Service Bulletin No. 1086

COACH MODEL	: C2045
BULLETIN TYPE	: Field Change Program: NHTSA campaign number 01V-176
MANUAL & SECTION	: Maintenance Manual : Chapter 11 - Body and accessories Spare Parts Manual : Section 753309 - Wiper
PARTS BOOK REVISION	: Yes
DATE	: June 27th, 2001
SUBJECT	: Windshield wiper linkage
TERMS & CONDITIONS	: Refer to the customer notification letter. Parts and labor allowance will be provided as per warranty information in this Bulletin.

Van Hool have determined that the windshield wiper actuating lever may become disengaged from the wiper motor shaft. If this occurs, the windshield wipers will cease functioning. The procedure in this Bulletin provides the necessary information to remedy this condition.

Figure 6 : Motor shaft clamp bolt

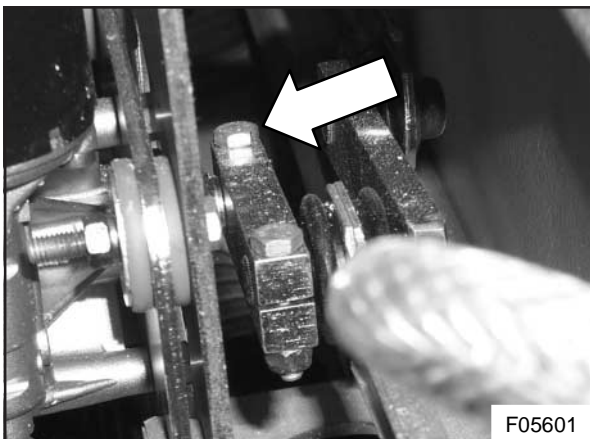
- 7) With a 10 mm box wrench and a socket and ratchet undo the bolt and nut securing the clamp to the wiper motor shaft (see Figure 6).

Figure 9 : Clamp (1) and bell crank (2) with "BRB" mark

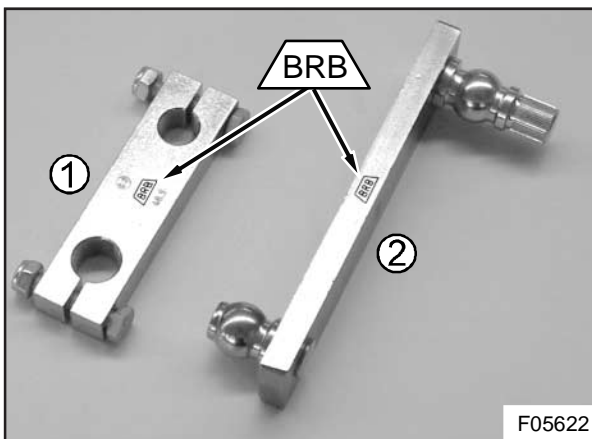
- Parts will be forwarded to customers, free of charge.
- Old and new parts are directly interchangeable.
- Only new parts will be offered as service replacements for this application.
- New bell crank and clamp can be identified by a "BRB" mark.
- Always use genuine maintenance products and parts. Do not accept imitations.

9) Disassemble the bell crank and clamp (see Figure 8 and 9). With a large screwdriver, separate the wiper tie bar from the bell crank. Take note of the dust cap installation on the tie bar. Note tie bar orientation. Note relative position of bell crank and clamp.

- 10) Salvage the old bell crank and clamp for certification purposes (see Warranty Information). Reassemble the linkage with new parts. Reassembly is the reverse of disassembly. Lightly lubricate the bell crank knuckle before installing the tie bar. Mind the dust cap installation. Make sure the bell crank knuckle shaft does not protrude through the clamp. The shaft end should be *flush* with the clamp. Do not tighten the bolts yet.
- 11) Switch on the ignition. Switch the wiper motor to the slow wiping position using the wiper switch. Switch the wiper motor off again. Switch off the ignition.

Figure 12 : Wiper motor dust cap installation (shown on the coach)

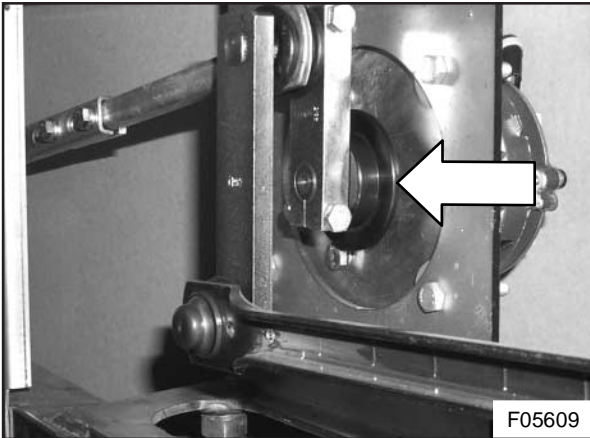
- 12) Install the motor shaft dust cap VH 10757900 (see Figure 10) by simply pushing it on the shaft as shown in Figure 11. Proper dust cap installation is shown in Figure 12.

Figure 13 : Linkage installed horizontally

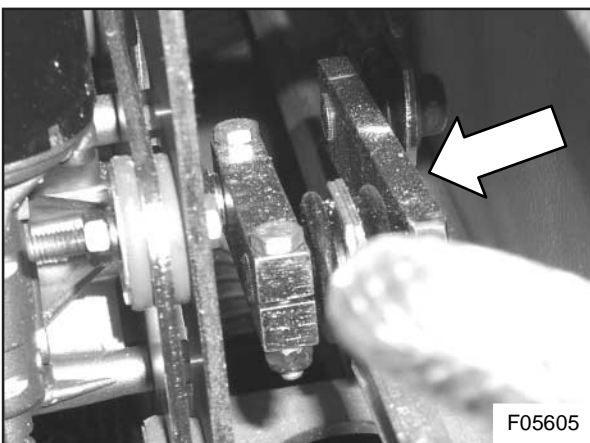
- 13) Reinstall the linkage horizontally on the wiper motor shaft as shown in Figure 13. Make sure the motor shaft end is *flush* with the clamp.

Figure 15 : Torqueing the clamp nuts

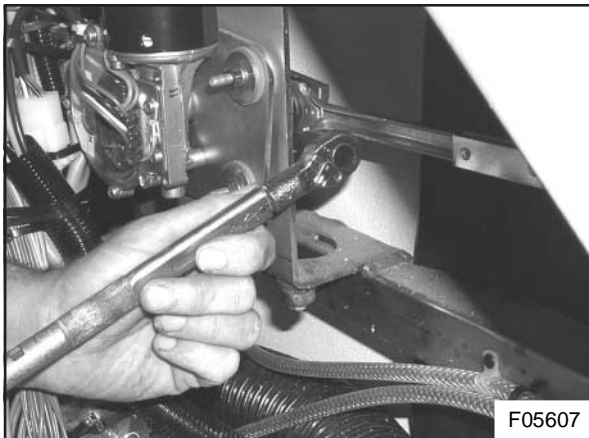
- 18) Tighten both the motor shaft bolt and the bell crank knuckle bolt to a torque of 9 to 15 ft.lbf (13 to 15 Nm) as shown in Figure 15.

CAUTION : Never install used fasteners for this application. Always fit new bolts and nuts.
